T.I. no.: 2019 - 28 Updated: -	Topic: Product optimisation: New milk hose – 00.0048.4939
--	--

Date: 11.12.2019	Priority	Need for action
Affected machines: SC Club	High	As soon as possible
From serial number: 21971 ff	X Medium	X On next visit to the machine
As of date: -	Low	FYI only

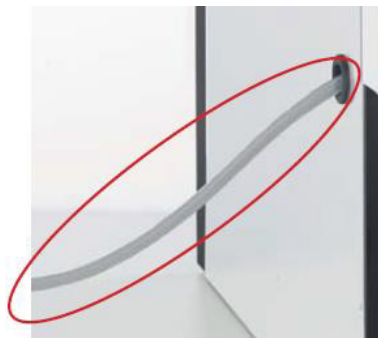
On your next visit, please inform the customer that the milk hose on a Schaerer Coffee Club must always be used with a Plug & Clean adapter and that the hose must always be pushed fully over the connection nipple of the Plug & Clean adapter. Further information is provided below.

The Plug & Clean adapter can still be used. The adapter must be removed from the transparent hose and fitted on the new hose. Please make sure that the milk hose is connected correctly – the hose must be pushed over the adapter as far as it will go; see figure on left.
